Re: PDS2015-MUP-98-014W2, PDS-2015-RP-15-001, LOG NO. PDS2015-ER-98-14-016B; SCH NO. 2015081025; EL MONTE SAND MINING PROJECT

The purpose of this letter and the letters attached is to provide comments on the Draft Supplemental Environmental Impact Report (SEIR) for the El Monte Valley sand mine. For the reasons below, the Draft SEIR for the Project does not adequately describe the Project and fails to analyze the significant environmental impacts of the Project. Additionally, the project does not propose adequate mitigation measures or alternatives to address those impacts. It is necessary that the DRAFT SEIR must be revised to permit the public and the community of Lakeside an adequate understanding of the environmental impacts of this project.

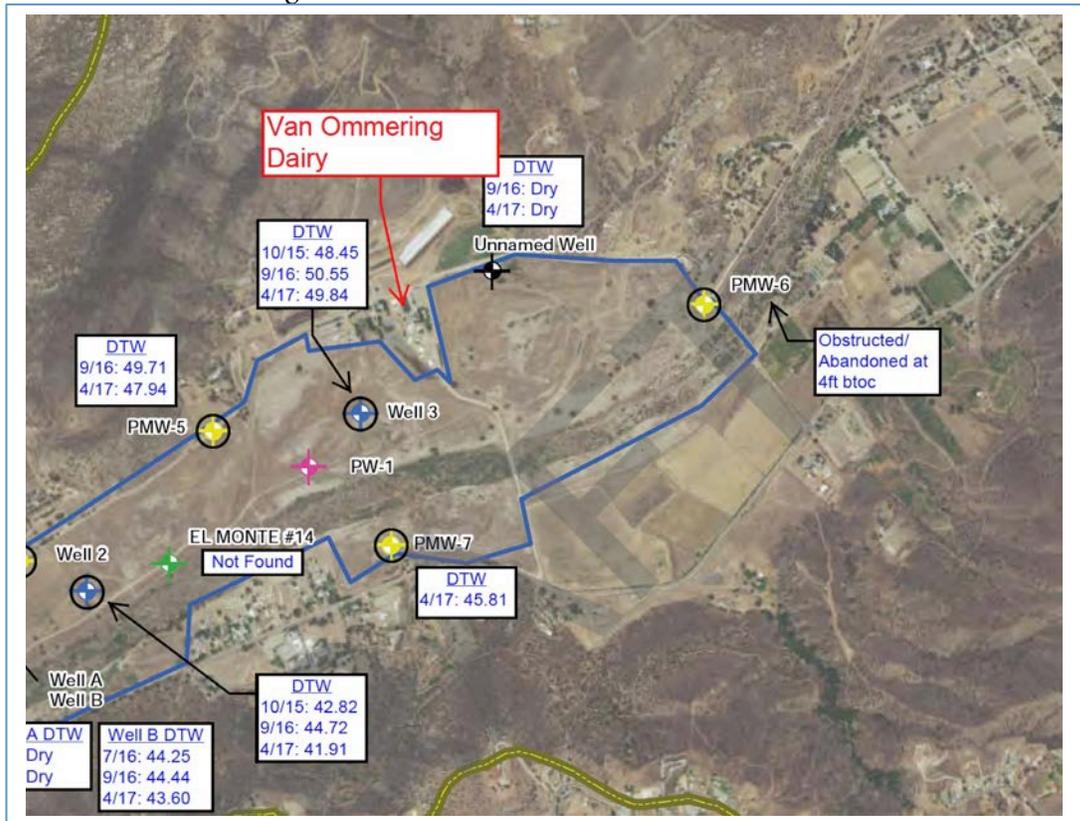
Please discuss whether the drop structure as proposed meets applicable engineering standards for its intended purpose. The drop structure is intended to keep flood flows from head cutting up the valley. Please study the 100 and 200 year flood year flows as well as anticipate dam failure. The Draft EIR does not examine flooding and dam integrity in light of climate change. Virtually all Global Climate Change Models show that California, and San Diego in particular, will experience warmer and drier winters punctuated by massive El Nino events.

- h. How does the drop structure proposed for the project affect hydrology and water quality in the Santee-El Monte Basin during and after construction of the structure? Is there be effects on the water table and aquifer?

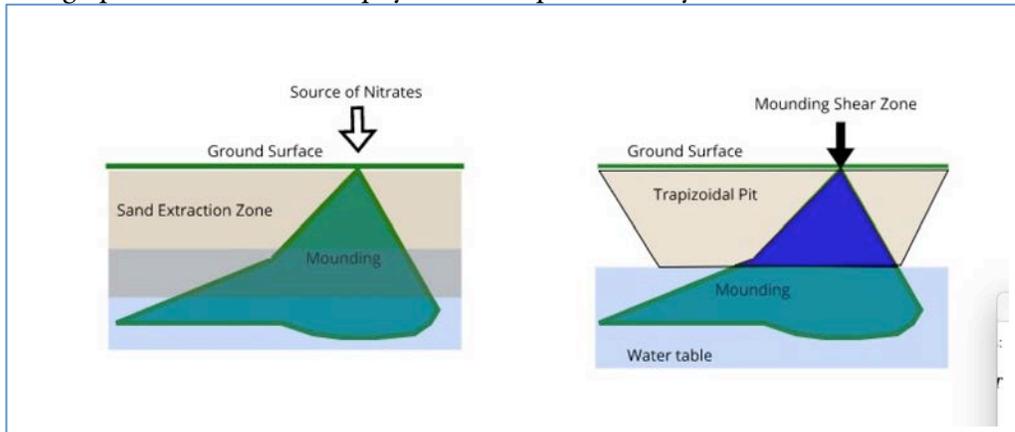
excessive pumping that will pull the mounding into a plume or by another activity. The existing groundwater and sand hold it in place and it only flows at the same rate as the groundwater it is in. However, the mine will be coming very close to the mound if not shearing into it. The portion of the mound that is held in place by the unsaturated zone, will then be able to flow down into the pit, increasing the concentration of nitrates in the groundwater just below the level of the pit. Essentially all of the mound that is above the ground water level will flow into the pit.

The graphic below shows the physics of this process in layman's terms.

The flood of 1978 severely exposed and weakened the pilings of the old highway 67 bridge over the San Diego River.

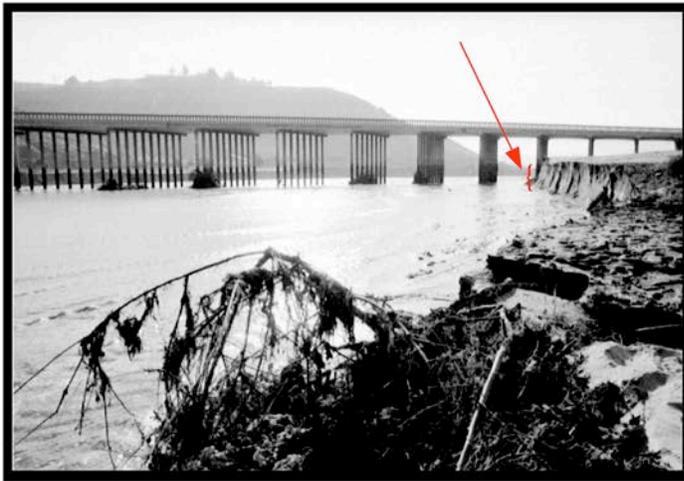
The large and deep sand mining pits had a catastrophic impact on Lakeside, particularly the Hwy 67 Bridge as it crosses the San Diego River. During 1977-1978 rain season and then again in 1981-1982 rain season, the dam over spilled generating 3010 and 2900 cubic feet per second of flow respectively. The damage caused to Lakeside is depicted in the photographs below.
